Access Compliance Report

Public Rights-of-Way

(Curb Ramps)

Intersection ID: 2454	Main Street: CLARKE_CREEK_PY	Cross Street: MILLSTREAM_RIDGE_DR	Location: NW
ADA ID: 595450593DCC	Ramp Type: ParaDiag	Initial Pass/Fail: Fail	Overall Compliance: No
		Severity Score: 35

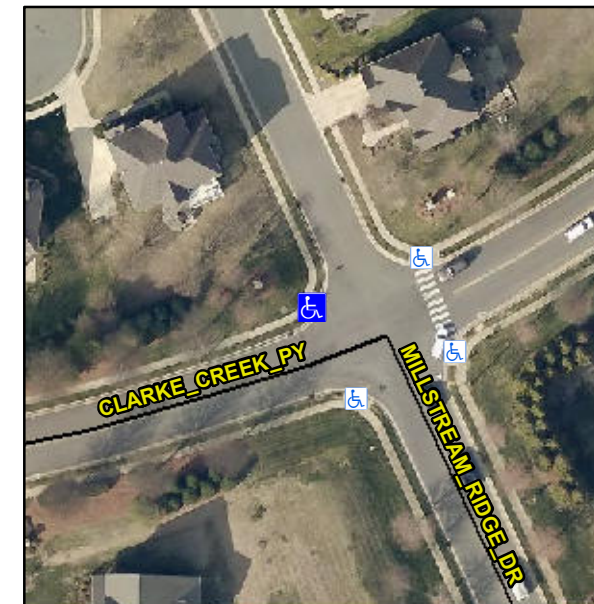
RT RP < 5%

R304.5.1, R304.3.2, R304.5.3

Remove & Replace Curb Ramp With Two New Directional Ramps or Equivalent.
